**Denali National Park and Preserve
Interior Region 11 – Alaska**

**FINDING OF NO SIGNIFICANT IMPACT
Ghiglione Bridge Replacement**

Appendix B:
NPS Responses to Public Comments on the Environmental
Assessment for Ghiglione Bridge Replacement

Figure 2 Pilings and Bridge Elevation Above Sea Level

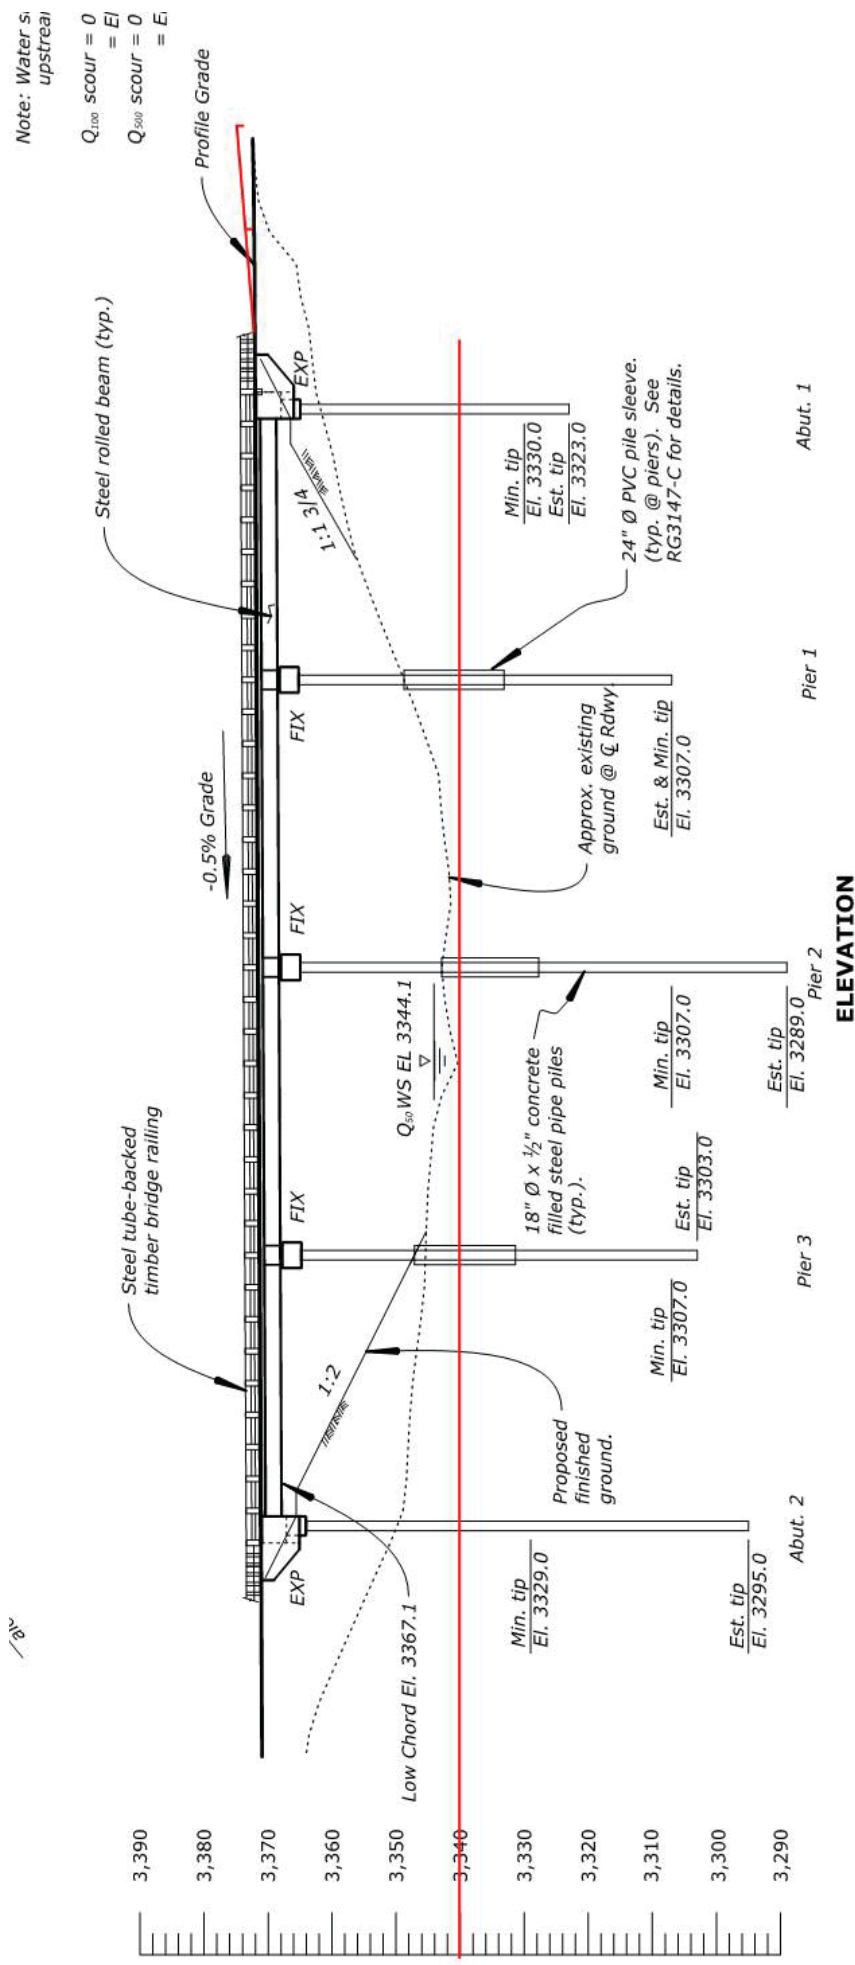
Two comments requested clarification on the elevations related to the bridge height, creek height, and pilings depth as listed in the Environmental Assessment.

The heights and depths referenced in the Environmental Assessment are all tied to the elevation above sea level.

The NPS acknowledges the 3,200 feet elevation for the creek at the point it is crossed, as listed on Page 2 of the Environmental Assessment, is incorrect and should be corrected to 3,331 feet. This is corrected in Appendix A: Errata Indicating Text Changes in the Ghiglione Bridge Replacement Environmental Assessment.

The new bridge will cross the Ghiglione Creek at 3,344 feet above sea level (70 feet upstream of existing bridge). The bridge deck itself is at 3,369 feet above sea level (the 3,367 feet noted in Figure 2 of the FONSI refers to the beams below the bridge deck).

The red line in Figure 2 marks the elevation of 3,340 feet, which is the height to which vibratory piling can be used. Below the elevation of 3,340, the contractor will need to use an impact hammer to drive the tip (or bottom) of the pile down to the minimum elevations for each pile (also known as a pier, as seen in Figure 2).

Bridge piers 1, 2, and 3 will rest approximately 19 feet, 25 feet and 23 feet above the finished grade, respectively. Approximate expected depths of the piers and abutments are as follows: Piers 1 and 3 will be driven 43 feet into the ground, pier 2 will be driven 55 feet into the ground, abutment 1 will be driven 39 feet into the ground, and abutment 2 will be driven 55 feet into the ground. See Figure 2 on Page 11 of the FONSI.
